Debris Flow event on Osorno volcano, Chile, during summer 2017: New interpretations for chain processes in the Southern Andes.

1. Reviewer 1: Abstract

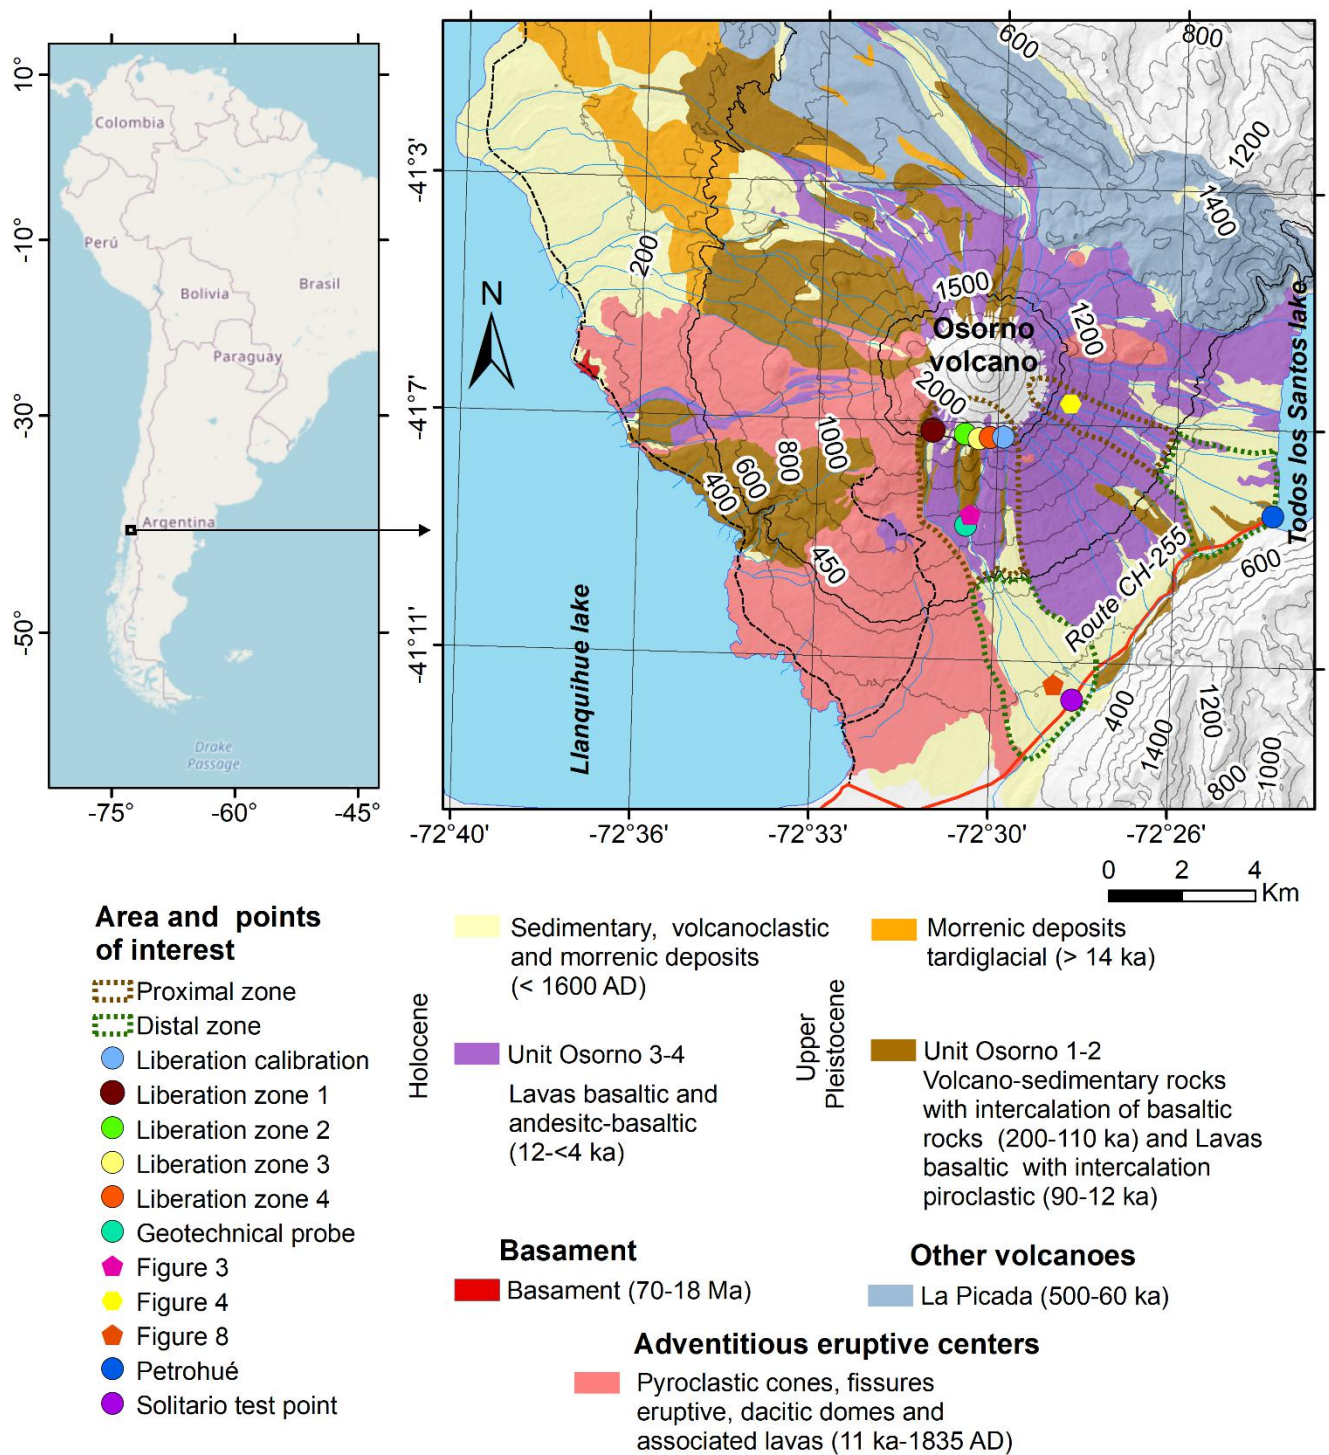
3. Reviewer 1: Figure 1. It is difficult to read the text of the figure. Maybe the font size is too small or probably it is solved easily increasing the size of the figure.

A: We change figure 1 with an improved figure with higher resolution.
